# **U.S. EPR Design Certification Review RLBLOCA Methodology**

AREVA NP Inc. and the NRC  
October 8, 2009

**Obtain NRC feedback on proposed  
RLBLOCA analysis approach to  
support initiation of revised Chapter  
15 calculations and preparation of  
Revision 1 of ANP-10278P**

## **C- Open Issue: Accumulator N<sub>2</sub> Injection**

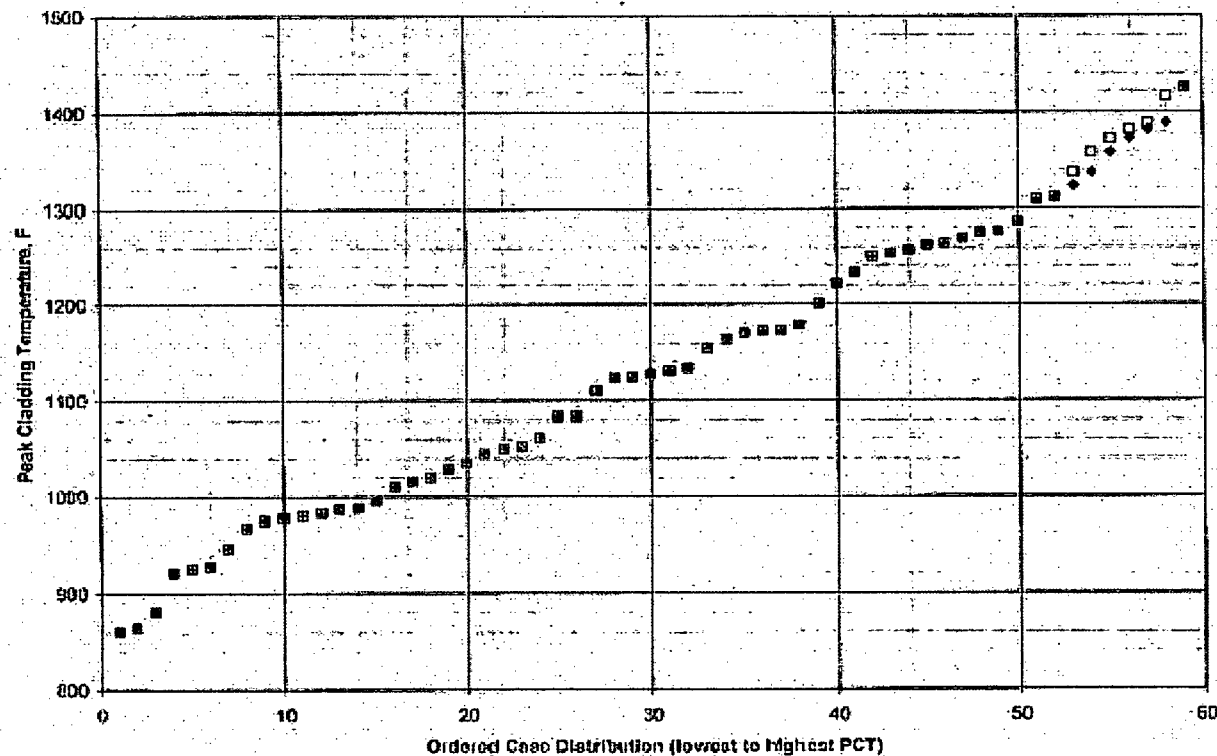
Staff questioned whether S-RELAP appropriately predicts the critical flow in the presence of nitrogen

1. Allow nitrogen injection or

2. [ ]

**Evaluation:** Allow nitrogen Injection

**Estimated PCT Impact:** minor

F- Open Issue: Number of Cases (124 vs. 59)

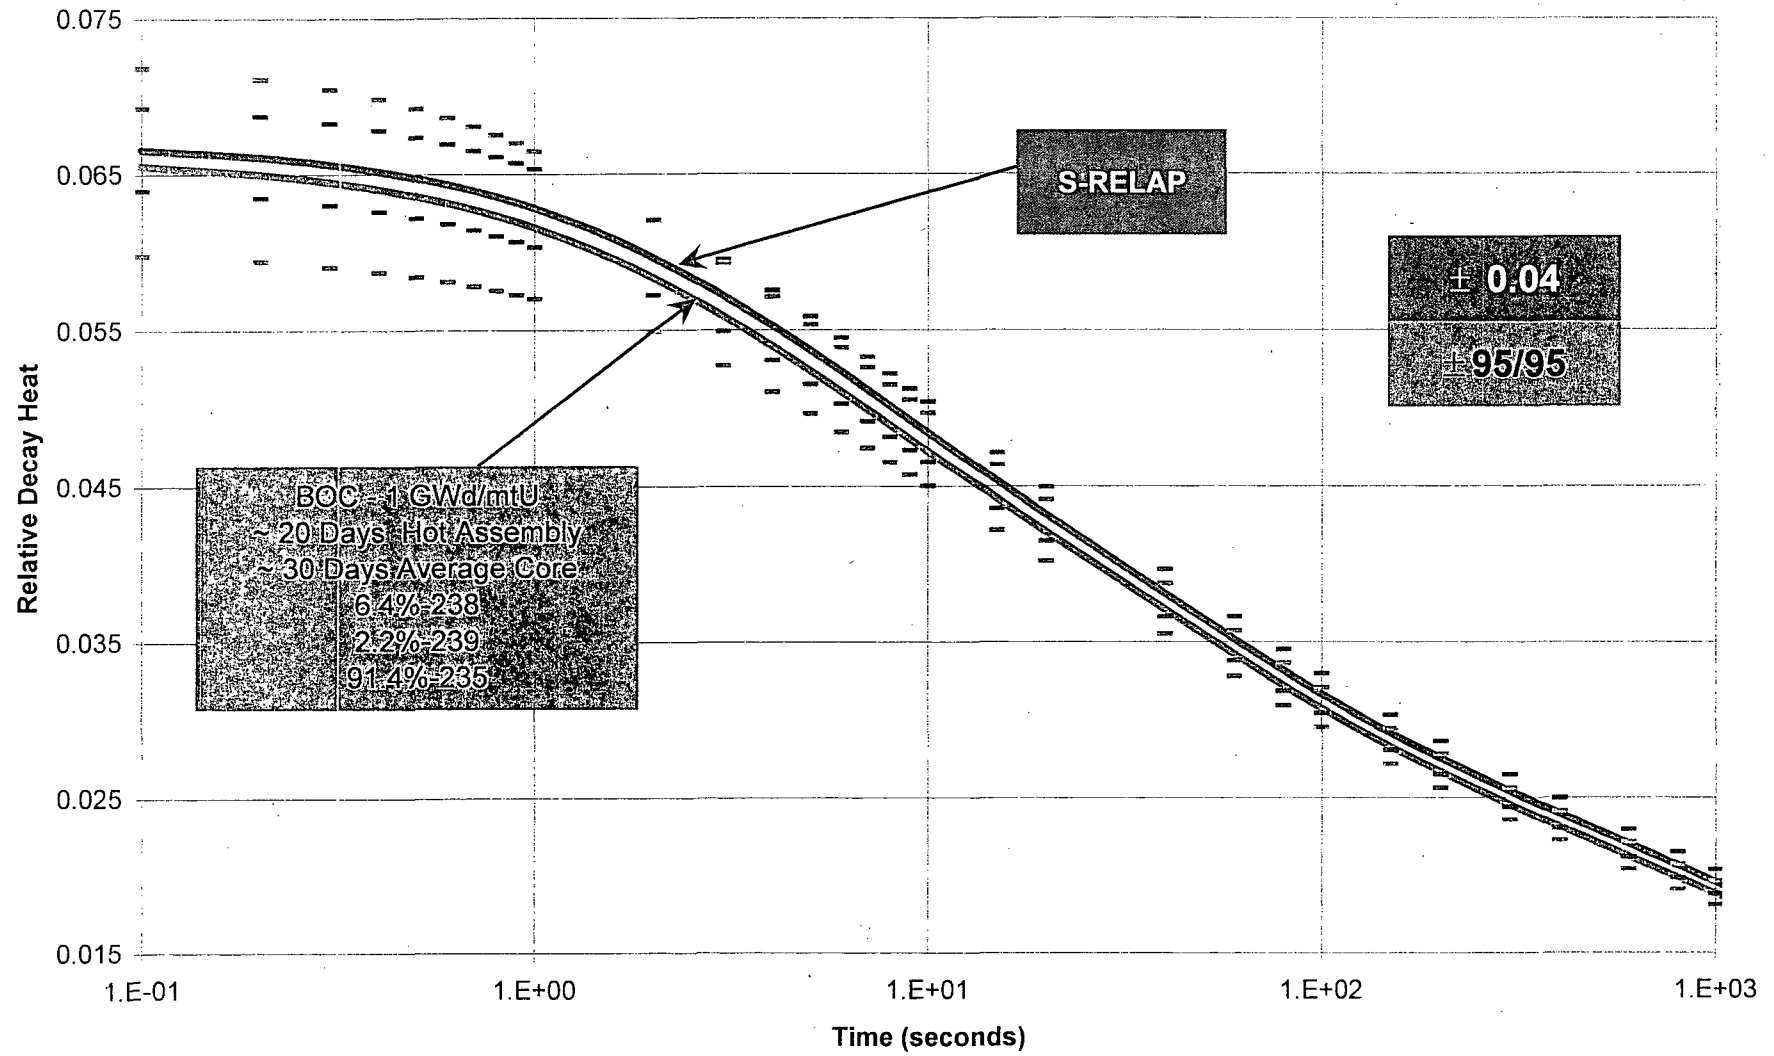
**Staff Initial Position:** Run 124 cases instead of 59 cases

**AREVA's Proposed Resolution:** Agreed with the staff position

**Evaluation:** Accept AREVA's proposal to run 124

**Estimated PCT Impact:** ~ 100 F
